UNITED STATES PATENT AND TRADEMARK OFFICE

APPLICATION NO.	FILING DATE	FIRST NAMED INVENTOR	ATTORNEY DOCKET NO.	CONFIRMATION NO.
09/925,343	08/09/2001	Gerd Jakob Ernst Scheller	CH 000016	4400

Office Action Summary

DETAILED ACTION

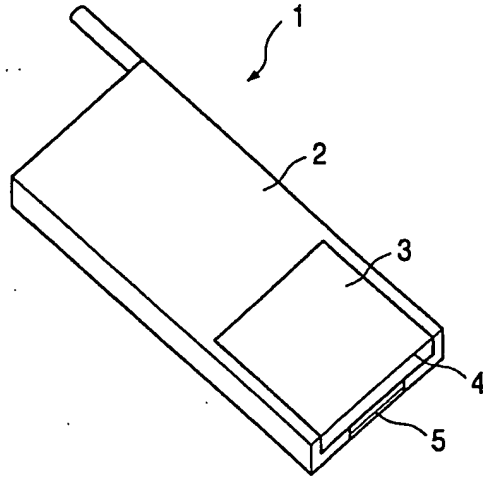
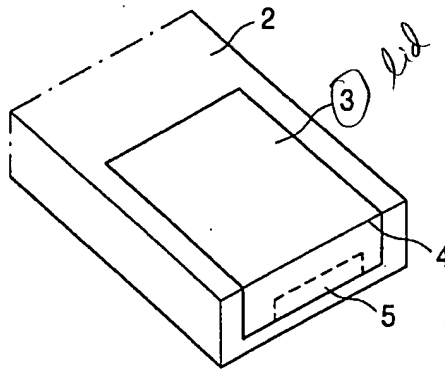
5. The drawings are objected to under 37 CFR 1.83(a) because they fail to show a legend describing the labels on the Figures as described in the specification. Any structural detail that is essential for a proper understanding of the disclosed invention should be shown in the drawing. MPEP § 608.02(d). Corrected drawing sheets in compliance with 37 CFR 1.121(d) are required

legend problem

in reply to the Office action to avoid abandonment of the application. Any amended replacement drawing sheet should include all of the figures appearing on the immediate prior version of the sheet, even if only one figure is being amended. The figure or figure number of an amended drawing should not be labeled as "amended." If a drawing figure is to be canceled, the appropriate figure must be removed from the replacement sheet, and where necessary, the remaining figures must be renumbered and appropriate changes made to the brief description of the several views of the drawings for consistency. Additional replacement sheets may be necessary to show the renumbering of the remaining figures. The replacement sheet(s) should be labeled "Replacement Sheet" in the page header (as per 37 CFR 1.84(c)) so as not to obstruct any portion of the drawing figures. If the changes are not accepted by the examiner, the applicant will be notified and informed of any required corrective action in the next Office action. The objection to the drawings will not be held in abeyance.
